**AG-MI-2015-02-C-EN – Change of Measurement Method
from Cylinder Head Temperature to
Coolant Temperature**

Category C

29.04.2015

Design change of the Rotax 912 ULS and Rotax 914 UL cylinder heads (introduced 01.03.2013) regarding the measurement procedure for cylinder head temperature (CHT) respectively coolant temperature (CT)

Fig. 1 – New generation cylinder head (measurement of CT)

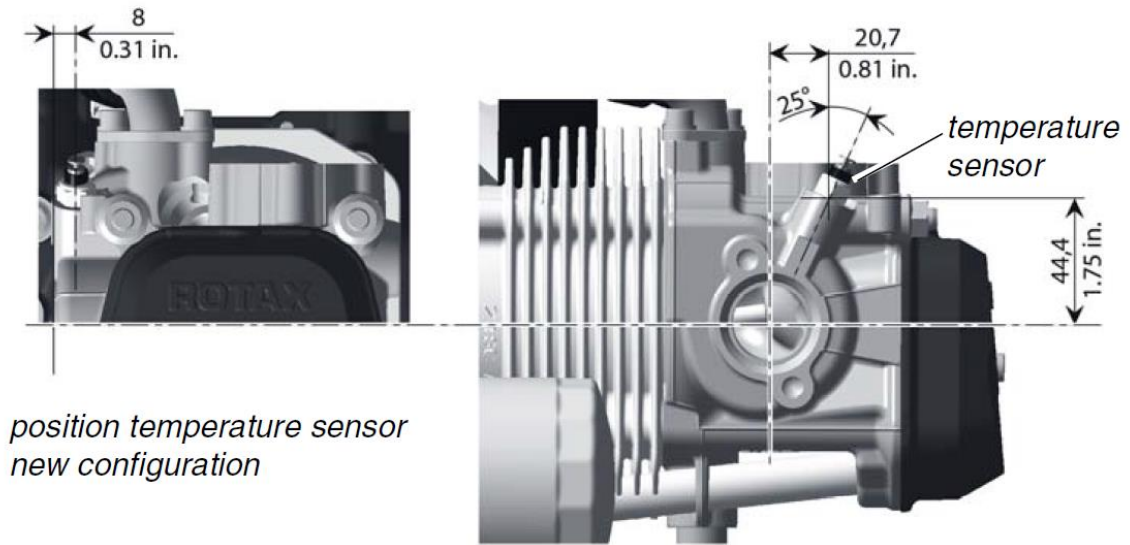
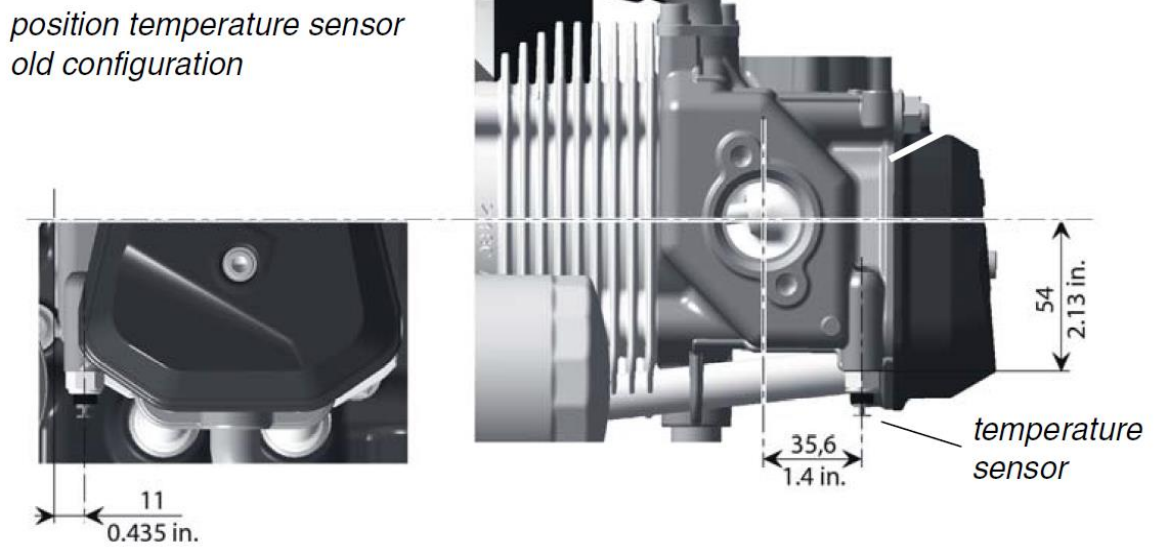
For engines equipped with new cylinder heads (see figures 1 and 2) change instrument marking of the cylinder head temperature indicator (CHT) to coolant temperature (CT). A replacement instrument will be purchasable later.

- 1 If necessary: Remove engine cowlings according to MMM 52-00-00 4-1
- 2 Check configuration state regarding cylinder head design (see figures 1 and 2)
If new cylinder head design is detected:
- 3 Clean CHT instrument glass with glass cleaner
- 4 Change cockpit instrument for cylinder head temperature (CHT) to coolant temperature (CT) using the modification set (see Parts List). Therefore in accordance with Fig. 3:
 - Stick the red radial on the instrument glass at 120°C
 - Stick coolant temperature pictogram on the instrument glass above "CHT"
